**PLANNING COMMISSION RECOMMENDATIONS  
TO THE BOARD OF COUNTY COMMISSIONERS  
December 5, 2013**

TO: Michael Mabrey  
FROM: Ejaz Khan, P.E.; Traffic Engineer   
DATE: October 1, 2013  
SUBJECT: Livingston Mountain Quarry Overlay District.

SUBJECT: Livingston Mountain Quarry Overlay District.

TO: Michael Mabrey  
FROM: Ejaz Khan, P.E.; Traffic Engineer EK  
DATE: December 27, 2013  
SUBJECT: Berry Road Quarry Overlay District.

**VICINITY MAP**

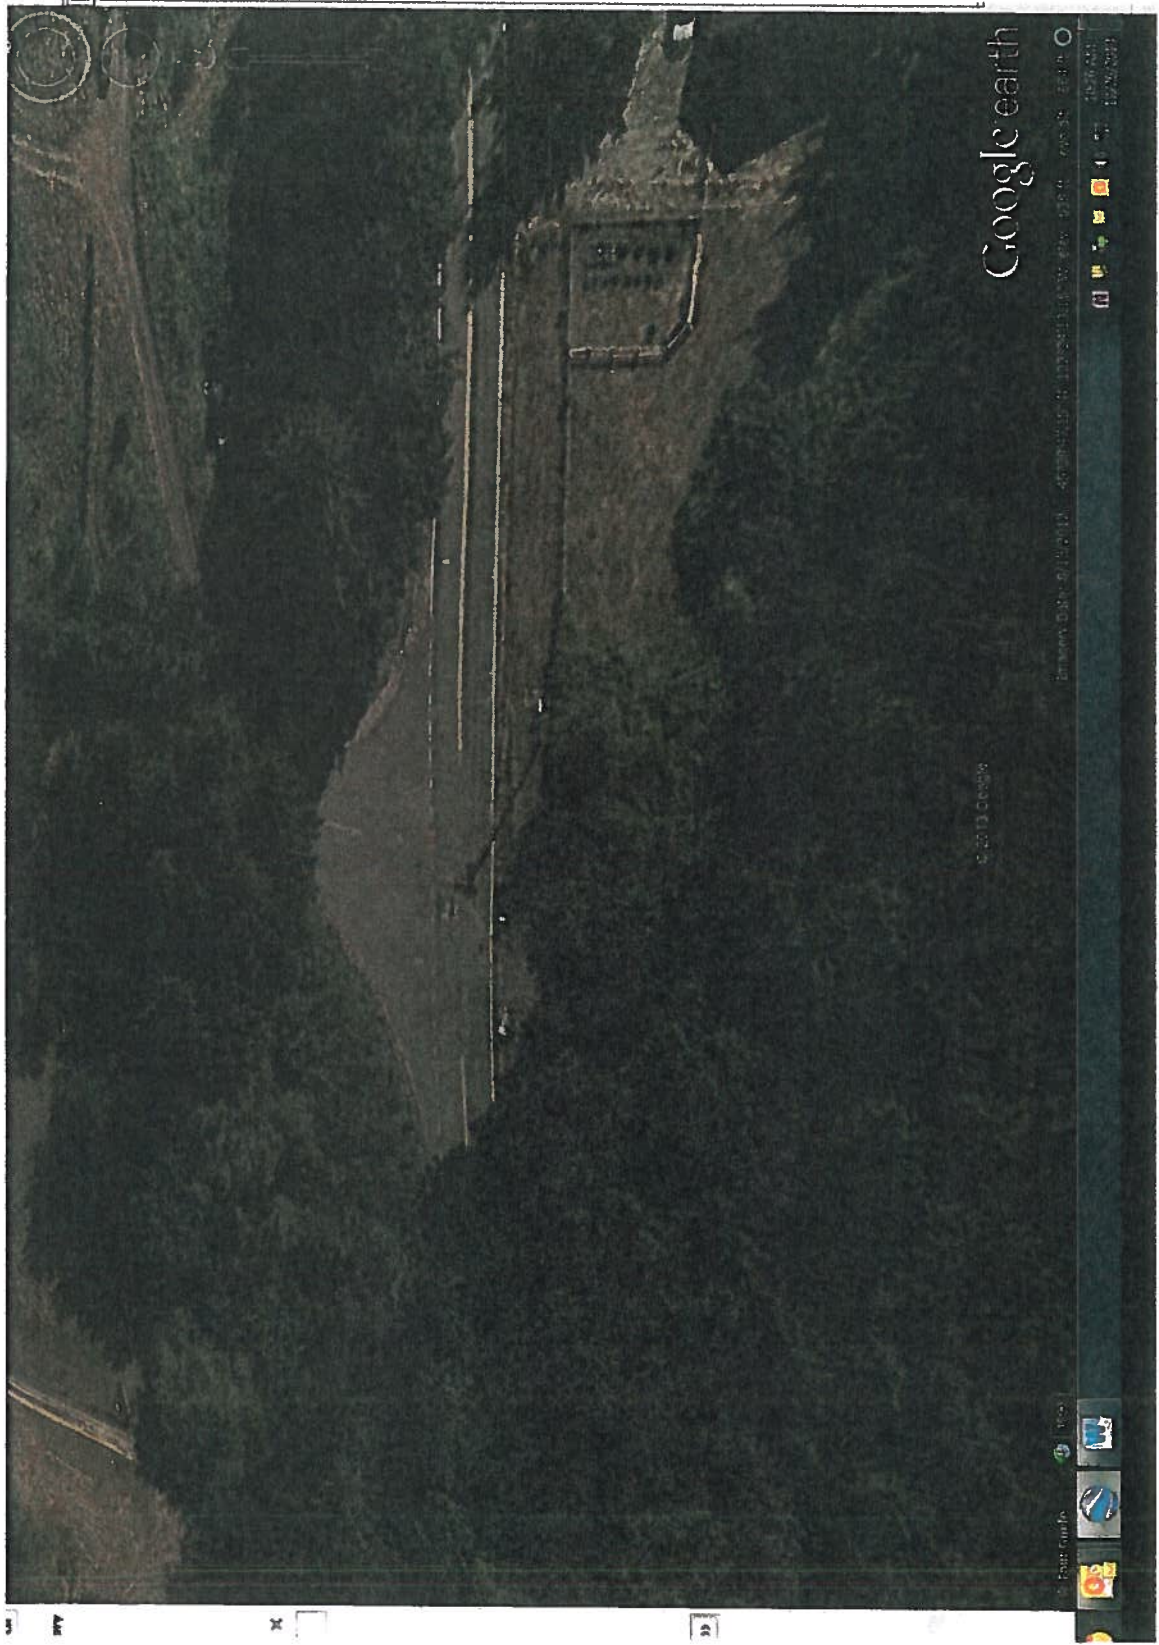
I have evaluated the suitability of NE 262<sup>nd</sup> Avenue roadway corridor for Quarry gravel truck movement, traffic safety and operations. The vicinity map in figure 1 highlights the corridor and intersection evaluated in this study. The trucks from and to the proposed mining area would access via NE 262<sup>nd</sup> Avenue off NE Bradford Road. NE 262<sup>nd</sup> Avenue is a two lane paved roadway with lane width ranging between 11 and 12 feet and some gravel shoulder. The dead end road of NE 262<sup>nd</sup> Avenue was recently overlaid by the County and the pavement appears to be in excellent condition. The corridor is unposted for basic speed and is centerline stripped. The corridor is well signed with appropriate traffic control devices and warning signs for safe traffic operations. The corridor has some horizontal and vertical curves and grades up to 16%. Despite the terrain and corridor alignment, none of the horizontal or vertical curves were severe enough to inhibit the safe movement of quarry trucks or create traffic safety and operations issues. NE 262<sup>nd</sup> Avenue currently carries an ADT of approximately 300 vehicles per day. Crash data for the intersection indicate only one crash over a period of 5 years.

NE 262<sup>nd</sup> Avenue at Bradford Road- Aerial View

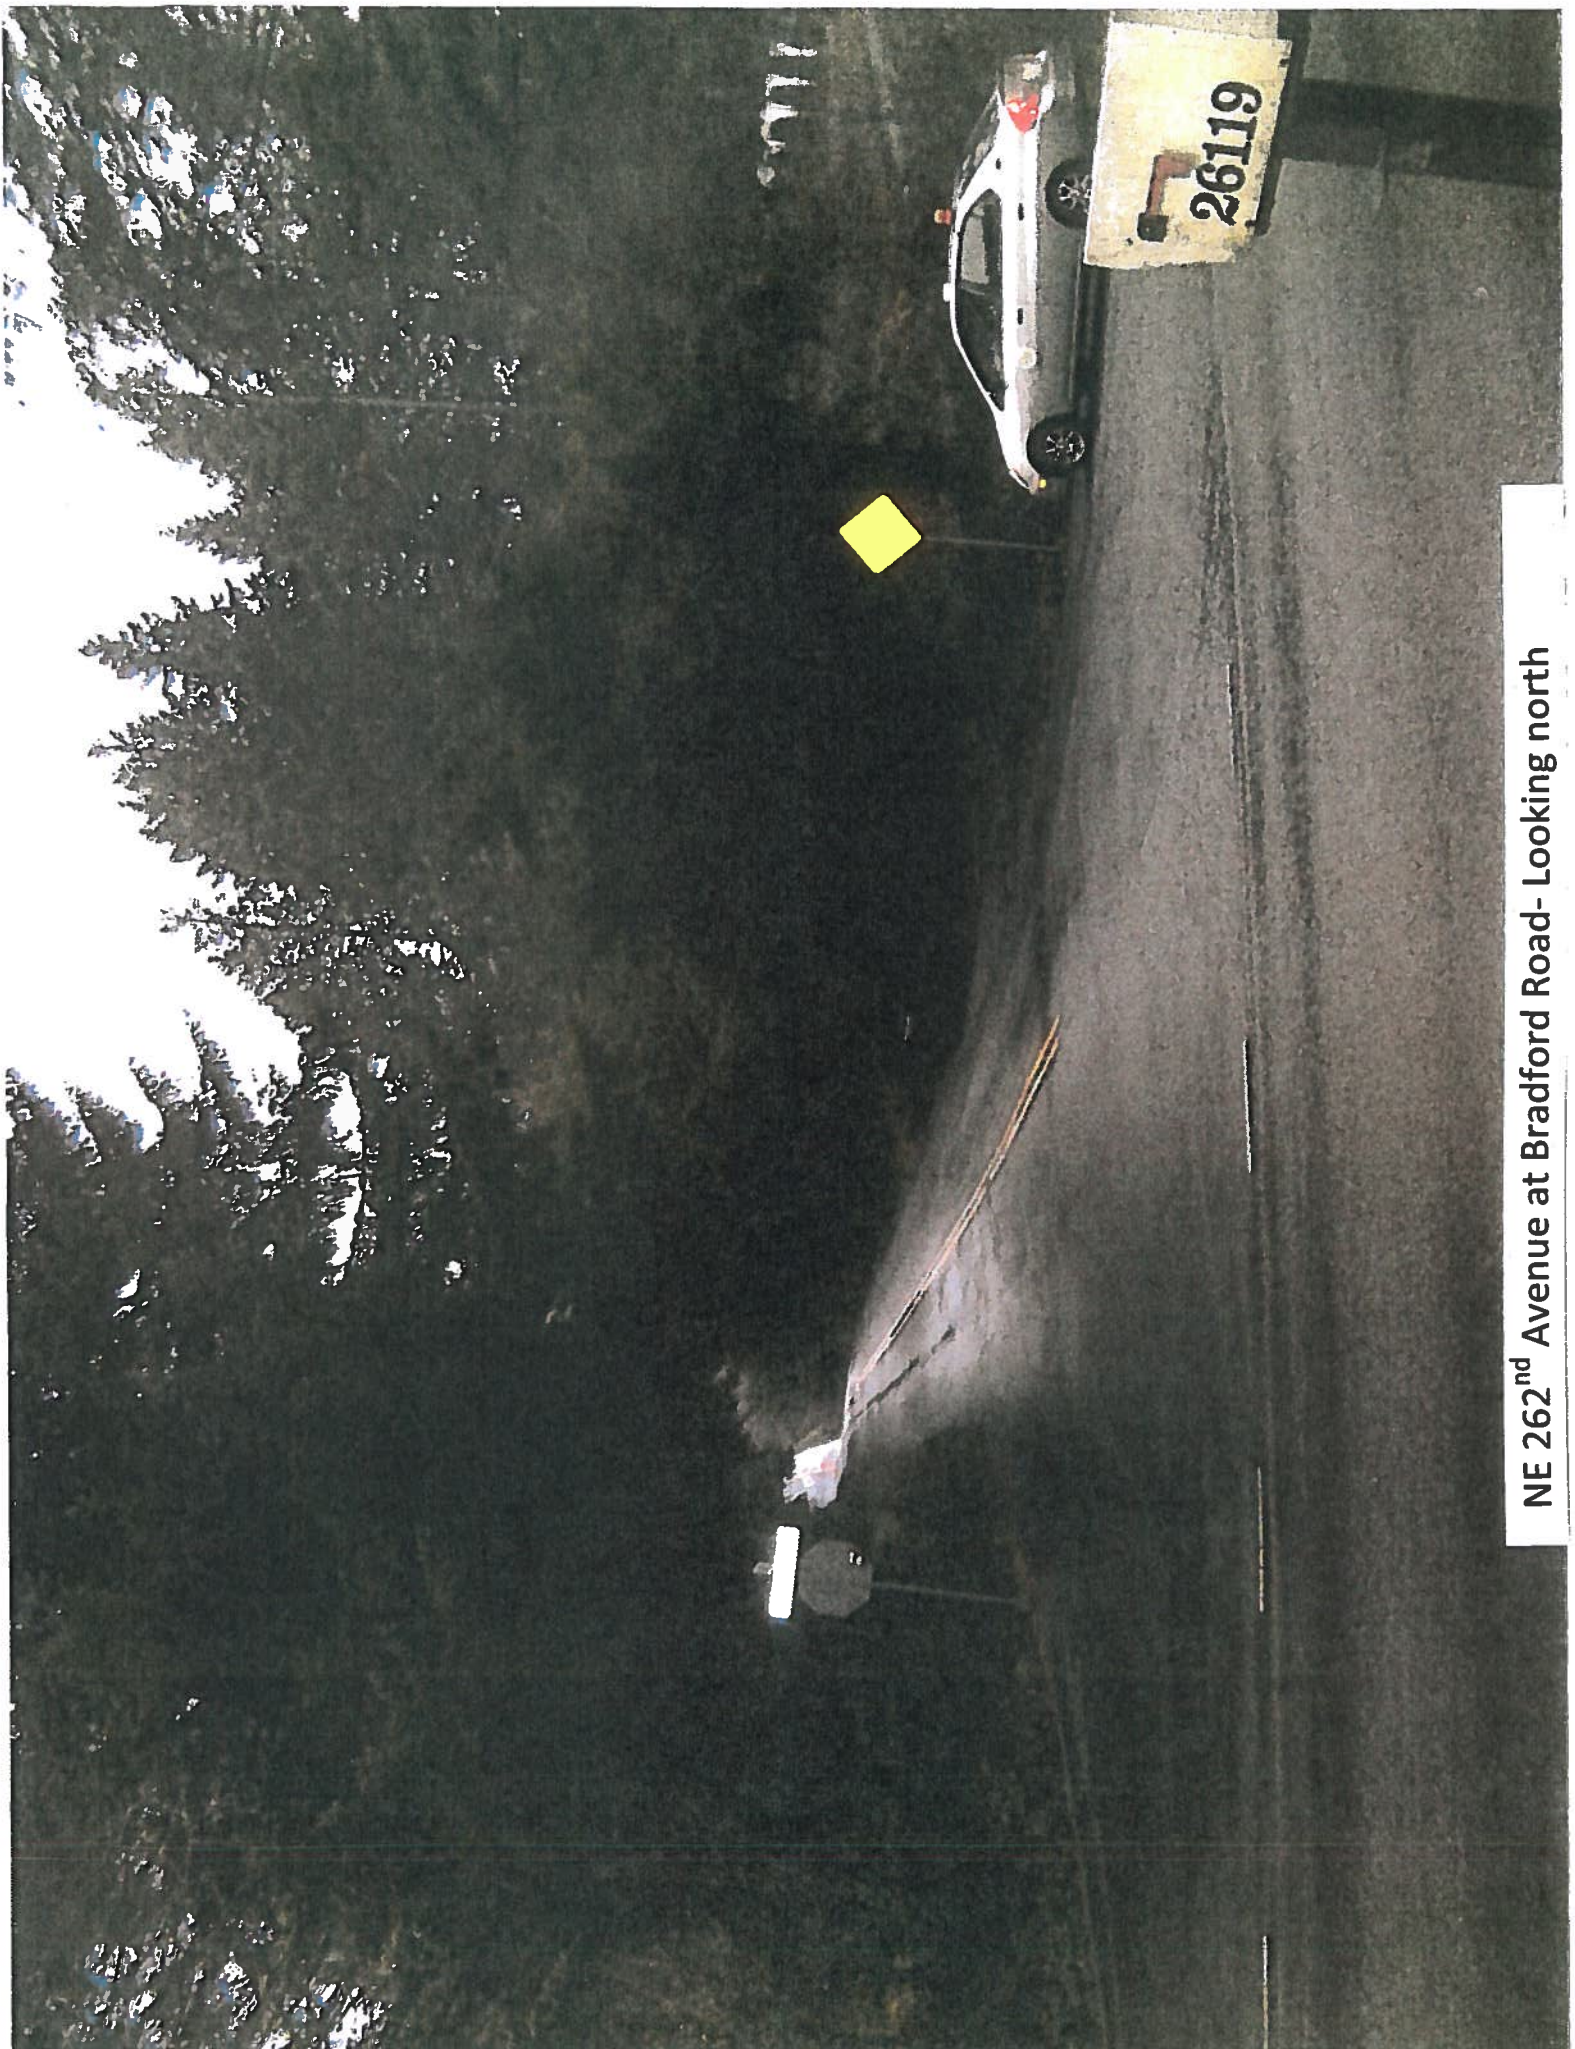
10. The visibility of vehicle eastbound on Bradford Road waiting to make a left turn was measured as 230 feet. This distance may not be adequate to prevent a rear end crash by a eastbound approaching vehicle. A more detailed study ascertaining left turn queue length, left turn lane warrants, operating speed and traffic volumes at the approach will be necessary to make a more definite assessment.

11. The intersection sight distance from NE 262<sup>nd</sup> Avenue, looking west (right) along Bradford Road was measured as 330 feet. This sight distance is not adequate for a safe left turn out of NE 262<sup>nd</sup> Avenue. A loaded gravel truck would require a much higher sight distance than the nominal sight distance of ten times the posted speed. A more detailed study would be necessary to determine the necessary intersection sight distance.

12. The intersection sight distance from NE 262<sup>nd</sup> Avenue, looking east (left) along Bradford Road was measured as 700 feet. This sight distance meets the minimum requirement for making a right turn out of 362<sup>nd</sup> Avenue. Note that the 700 feet sight distance was based on driver eye height of 3.5 feet.

7. The Stop sign on NE 262<sup>nd</sup> Avenue at Bradford Road is visible from sufficient distance to allow a safe stop. However, removal to two trees in the immediate vicinity of the STOP control will further improve the line of sight and consequently enhance traffic safety.

8. Since NE 262<sup>nd</sup> Avenue approaching Bradford Road is on a relatively long negative downhill grade, it is recommended that "Pavement friction management" be implemented at its approach with Bradford Road to ensure a safe stop by a loaded gravel truck.

9. Since NE 262<sup>nd</sup> Avenue approaching Bradford Road is on a negative downhill grade, it is recommended that the approach with Bradford Road be white topped (cement concrete pavement surface) to prevent southbound loaded gravel trucks from destroying the pavement.

NE Bradford Road at NE 262<sup>nd</sup> Avenue- Looking east (left)

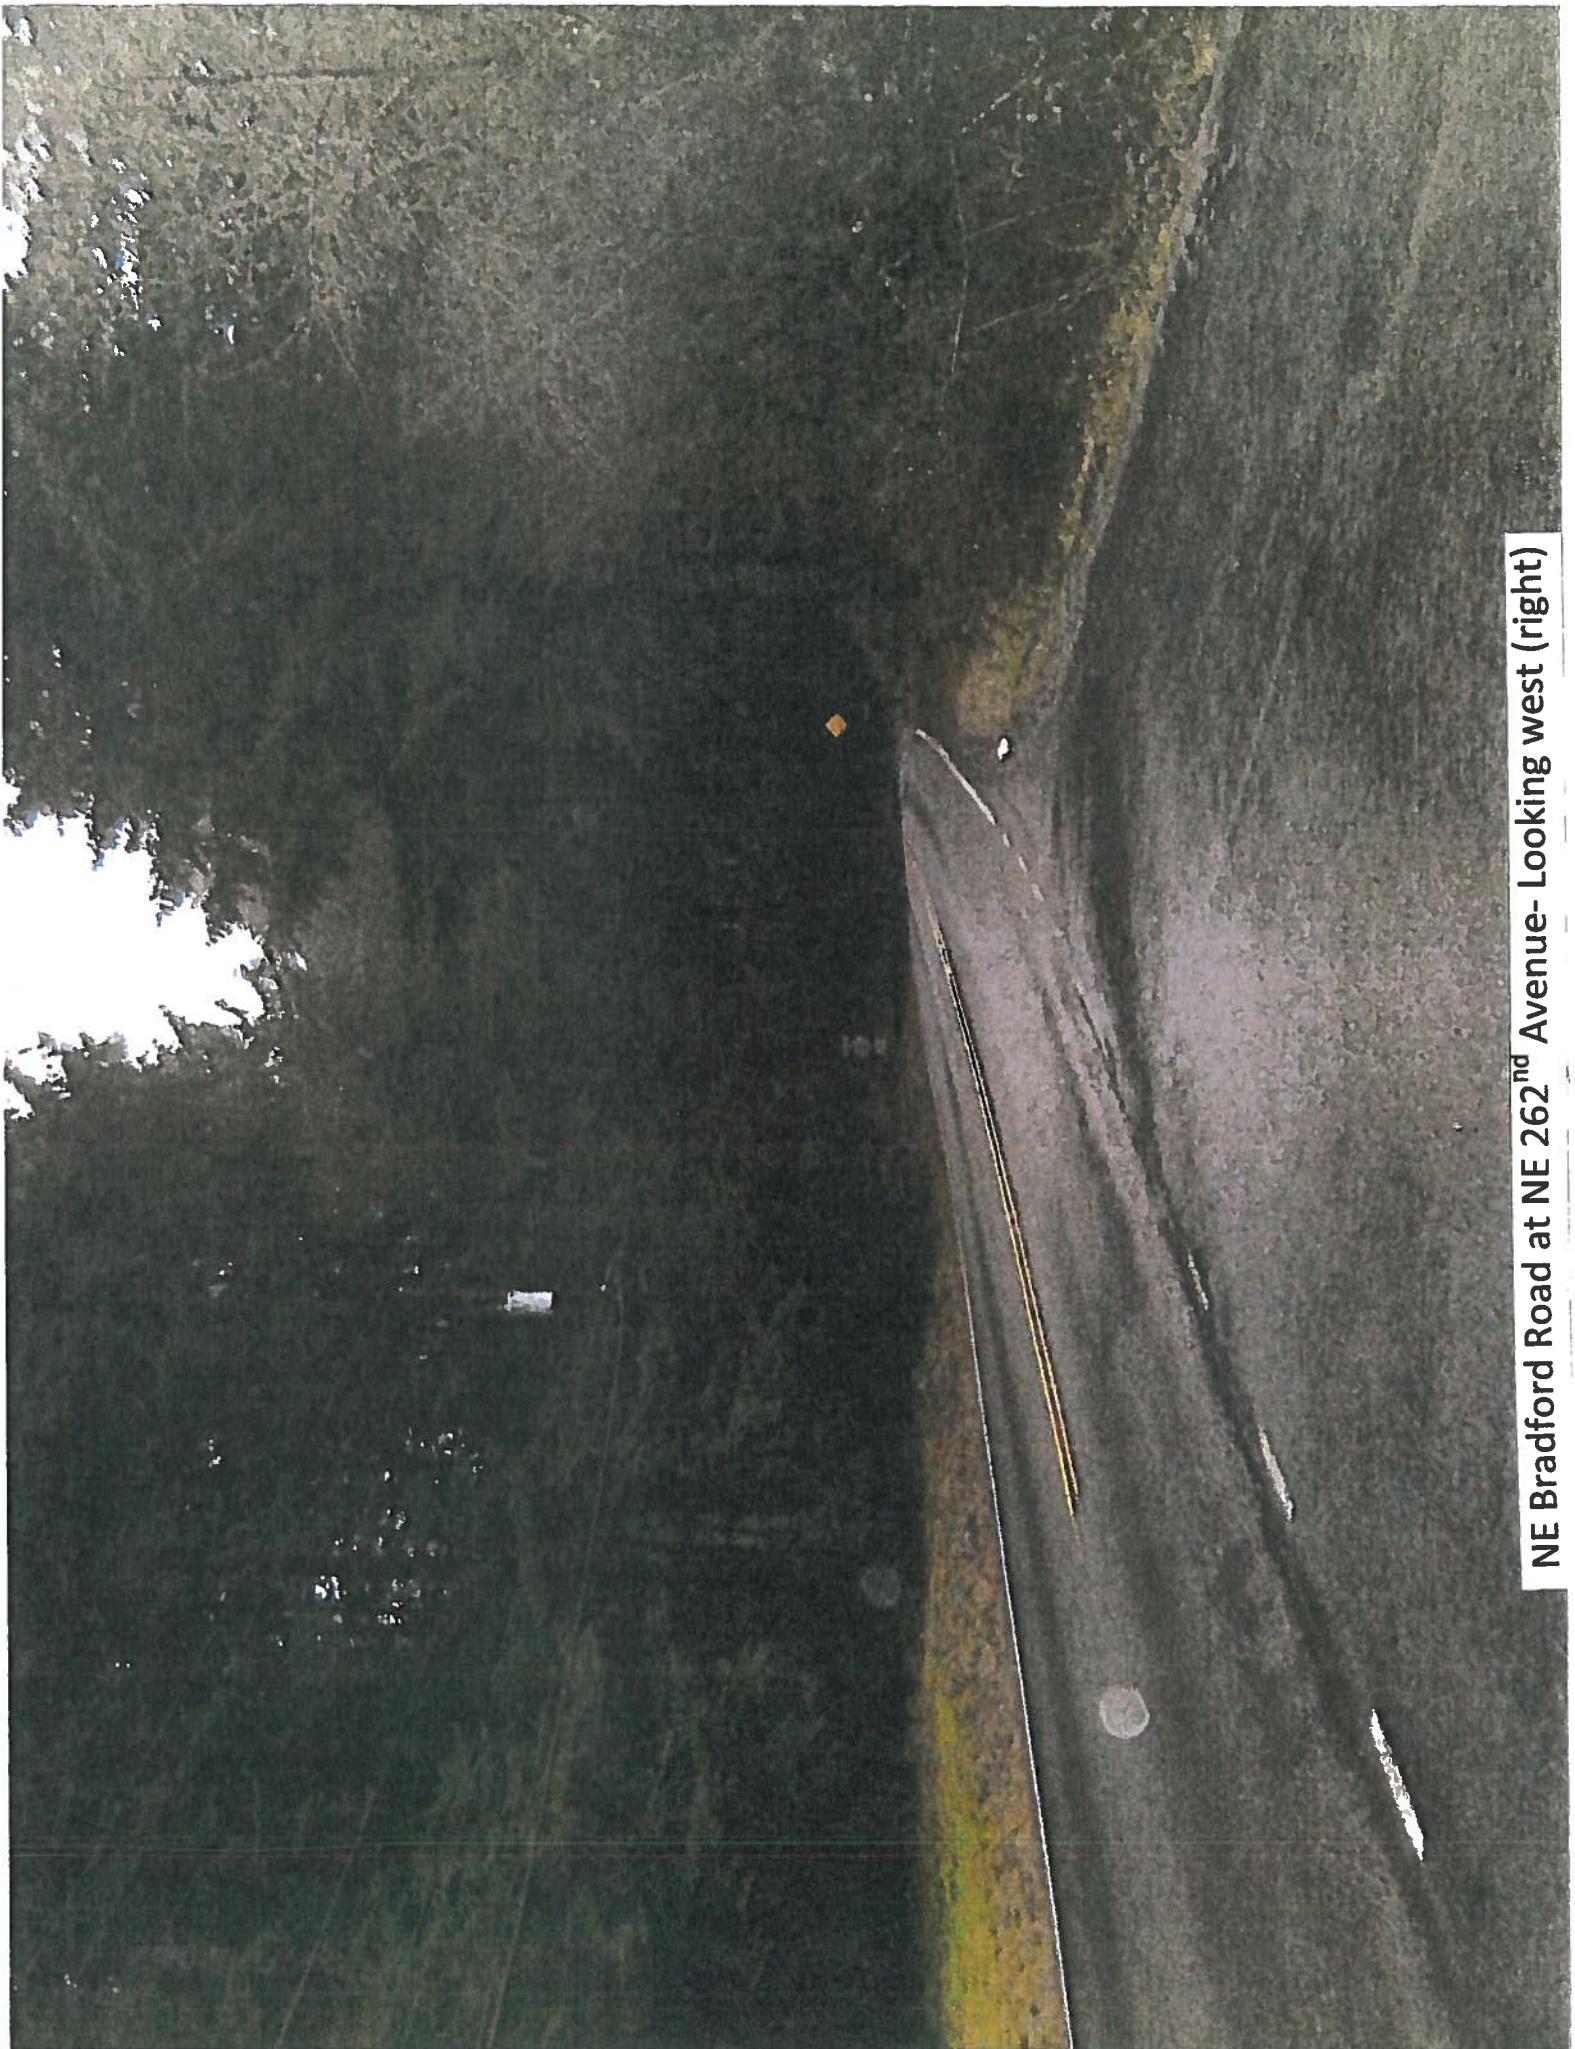
15. The intersection sight distance from Reilly Road, looking west (right) along Blair Road was measured as 1,475 feet. This sight distance is adequate for making a safe left turn out of Reilly Road.

16. The intersection sight distance from Reilly Road, looking east (left) along Blair Road was measured as 320 feet. This sight distance is inadequate for making a safe left turn out of Reilly Road. The vertical curve along Blair Road restricts the available sight distance. However, a much better sight distance would be available to the truck driver since the truck driver's eye is situated at a much higher level than a regular (sedan) passenger vehicle. Proper equipment was not available at the time of field visit to determine the intersection sight distance based of truck driver eye height and data could not be recorded.
